ONSITE SEWAGE DISPOSAL SYSTEM

PROPERTY ADDRESS: 12118 Hayland Farm Way

SUBDIVISION: Walnut Creek LOT: 25 TAX ID: _____

LOCATION DRAWING
12114 HAYLAND FARM WAY
 LOT 25
WALNUT CREEK
 CLARKSVILLE (5th) ELECTION DISTRICT
 HOWARD COUNTY, MARYLAND

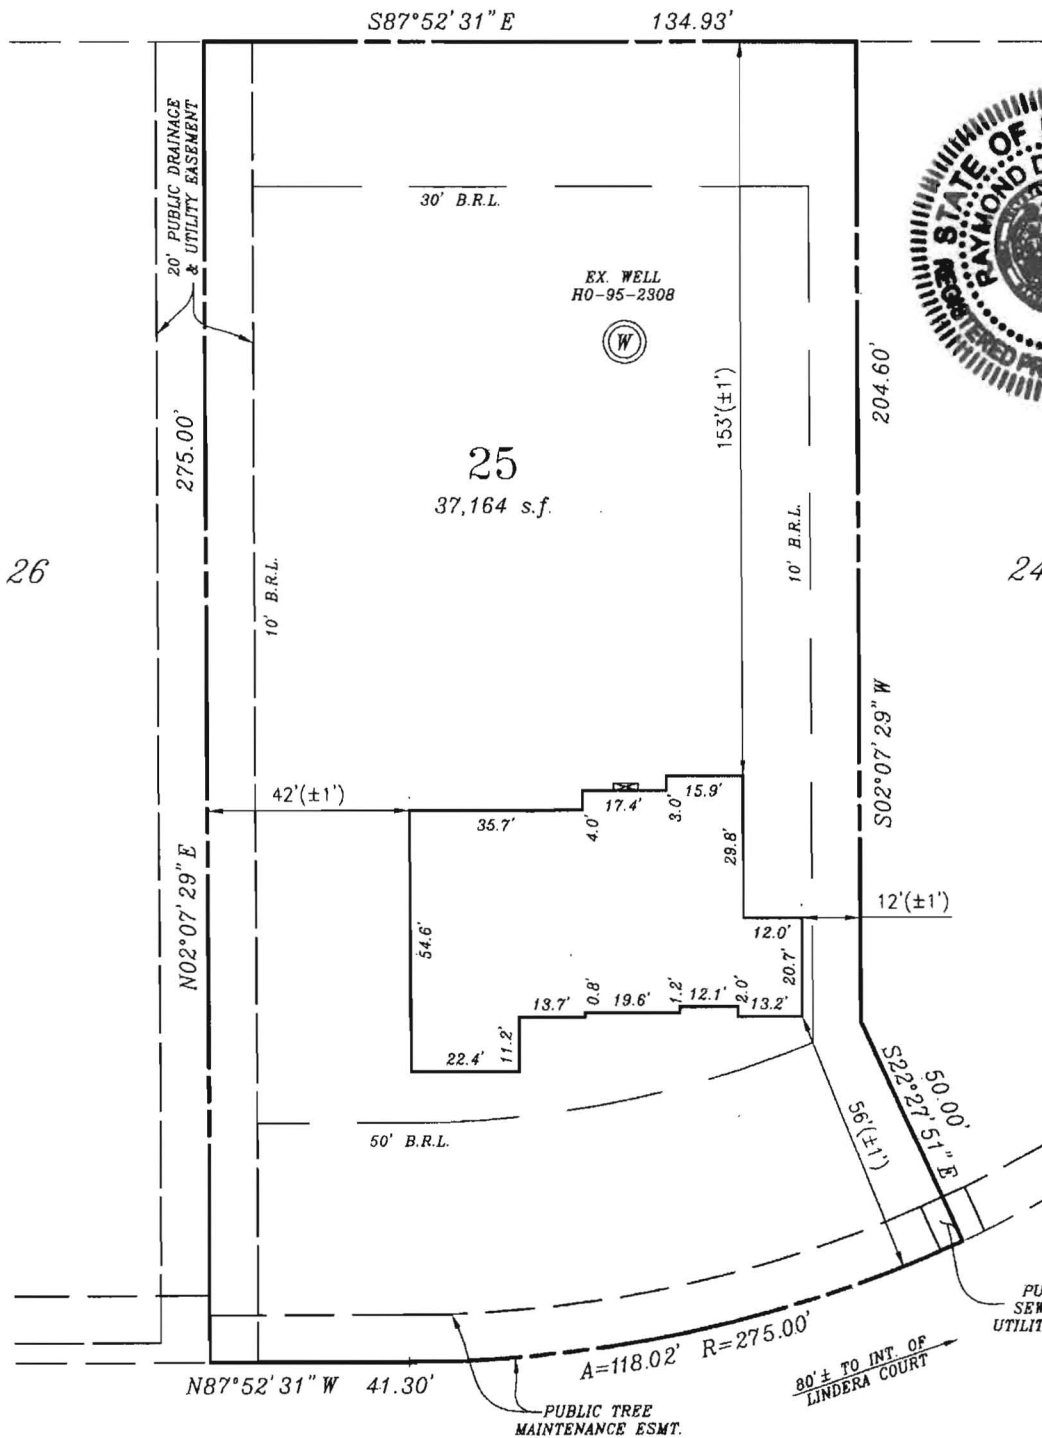
Sorry for the delay. I was out of the office unexpectedly for several days. I reviewed the attached file that I believe is associated with lot 25. The floor plan is showing 6 bedrooms. 4 on the 2nd floor, 1 on the first floor (labeled "study") and 1 in the basement (labeled "exercise room"). As you probably know, the Walnut Creek shared septic system requires a 5 bedroom limitation on all lots in the subdivision. You must revise the plan to make it 5 bedrooms or less. You could make either the basement or 1st floor rooms met our bedroom exemption if the bath were removed from the nearby bathrooms or if the room's doorway were expanded to at least 4' wide with no door. Below is our bedroom definition from Sec. 3.8 of the Howard County Code. Once you make your revisions, you will submit it to DILP as a formal revision with a copy for them to scan into Acella and send to the Health Dept. Thanks.

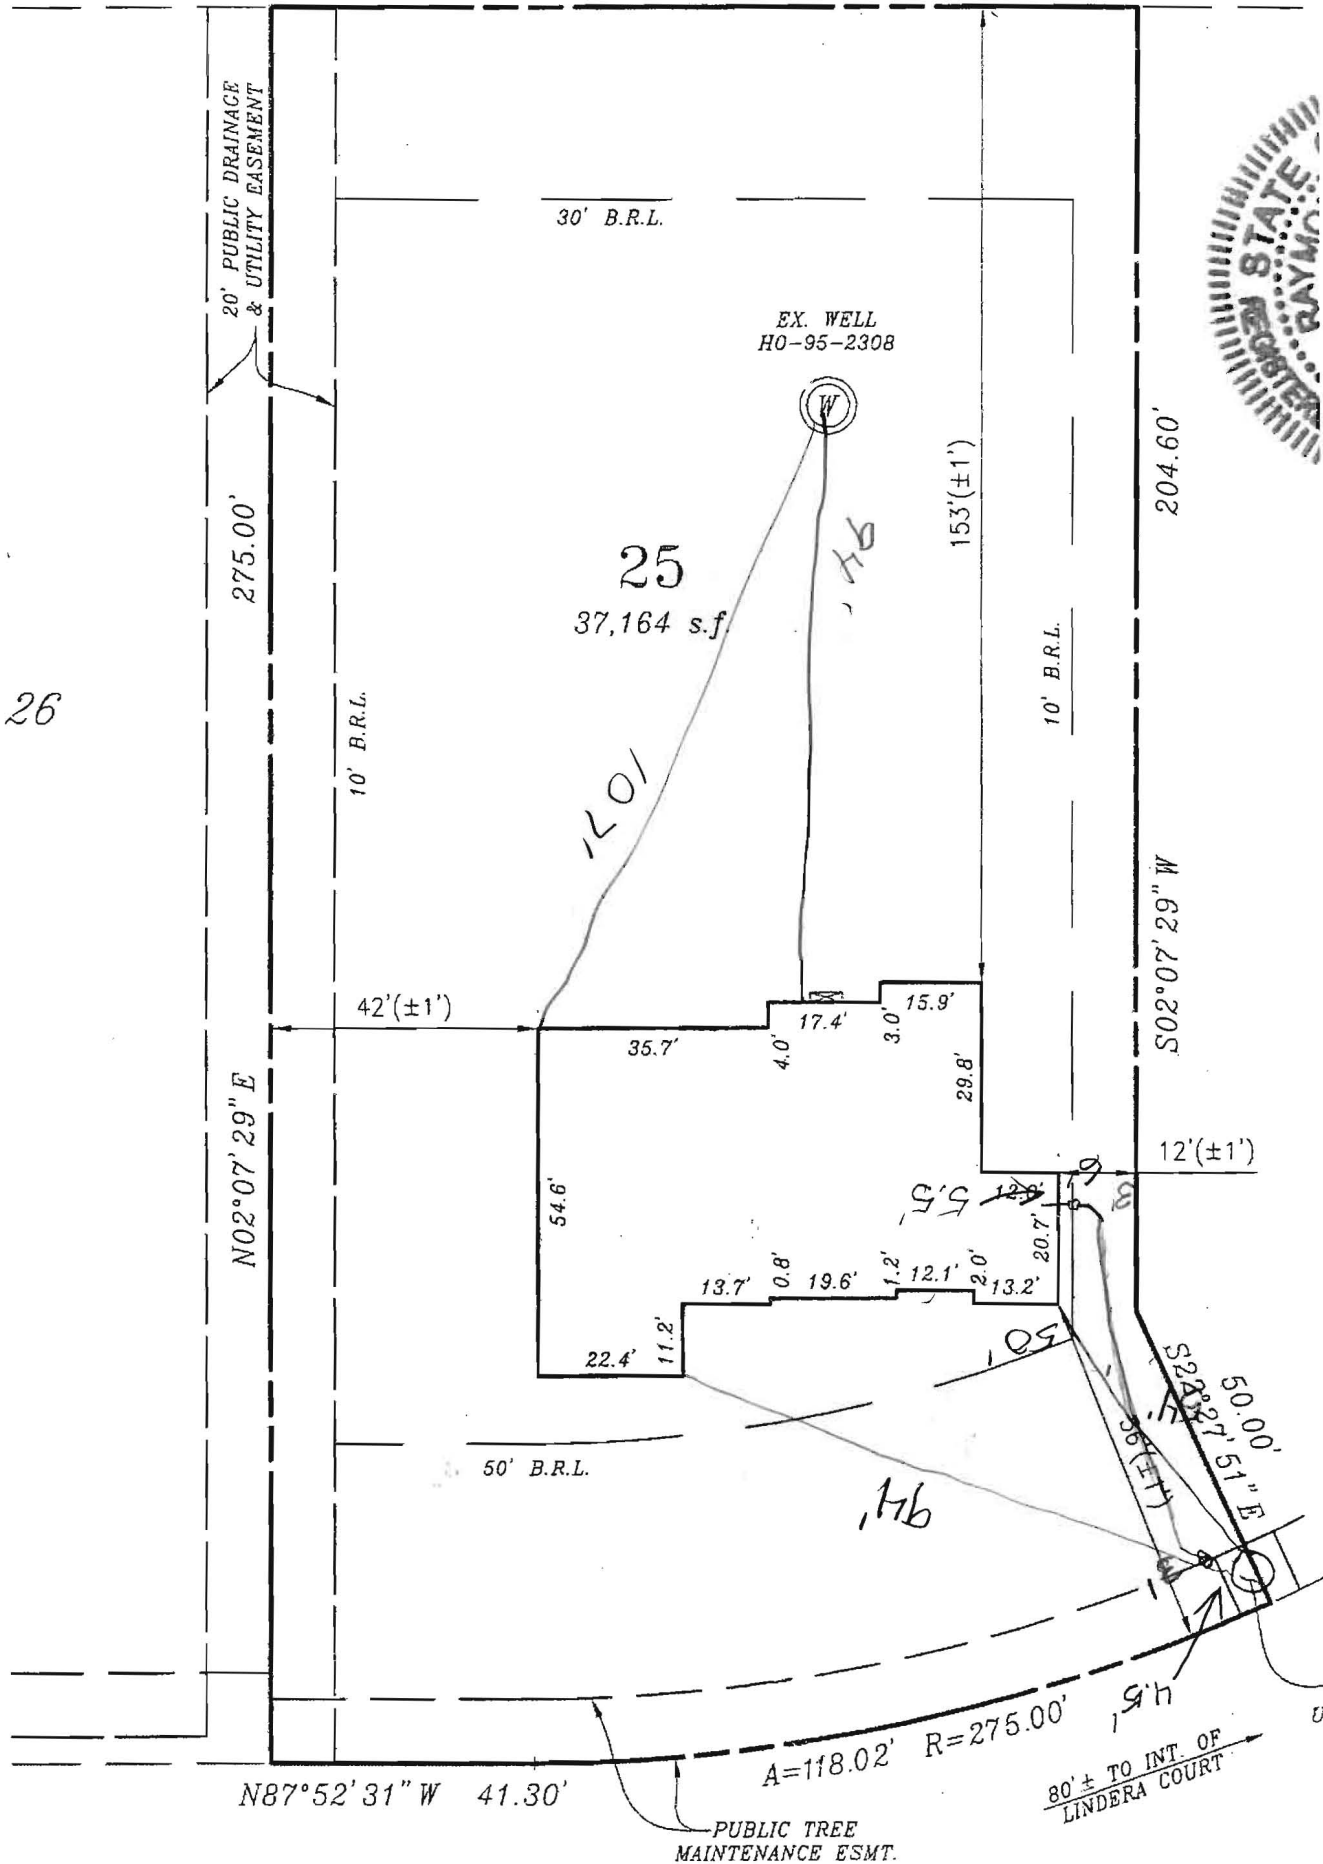
*Will check OK
 Jcw
 6/9/14*
